TECHNICAL SERVICE BULLETIN

Technical Service Bulletin: 77-0622

NO BOUNDARIES ("NO BO") – WINTERIZATION REMEDY INSTRUCTIONS

Figure 1

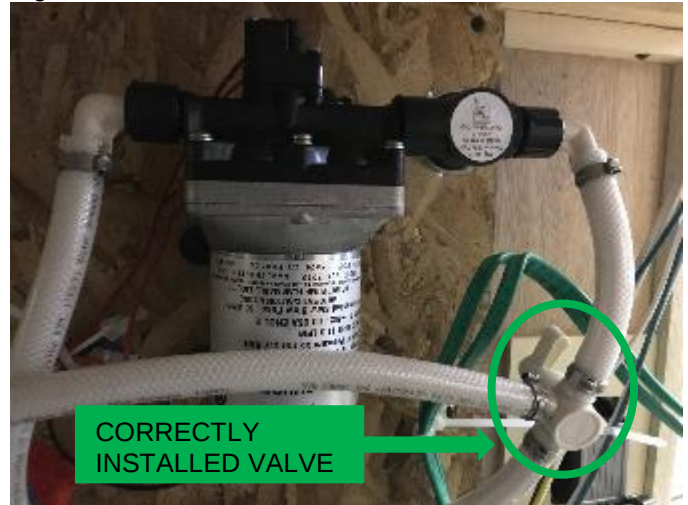
The manufacturing plant installed the winterization valve on the pressure side (vehicle side) of the water pump. The winterization valve should have been connected to the intake/suction side of the water pump. If the waterlines and water using components are not appropriately winterized from freezing, the components and waterlines may crack, break, etc. potentially voiding the component manufactures warranty.

Step 2: Inspect the 3-Way Valve location, if the Valve is on the Pressure Side of the water pump as shown in Figure 1, proceed to the remedy by ordering **KIT NUMBER: 60P15984A**;

Step 3: If the Valve is installed according to Figure 2, do not proceed with the remedy. *Claim the Inspection Code.*

Remedy – Refer to Figure 2 for the Remedy if needed

- Step 1: Using a cutting tool such as a box cutter, cut the white water hose close to the valve then discard valve assembly;
- Step 2: Slide the provided hose clamps on each of the white hoses;
- Step 3: Insert the waterline coupler into each hose and secure tightly with the hose clamps on each side of the coupler;
- Step 4: Cut the white water line hose approximately 4 inches from the 90° elbow;
- Step 5: Slide the provided hose clamps on each of the white hoses;
- Step 6: Insert the provided pre-assembled valve into each hose with the handle pointing towards the white waterline to the pump

Important note important: on the valve is the word "IN" ensure the valve handle is turned to cover this word
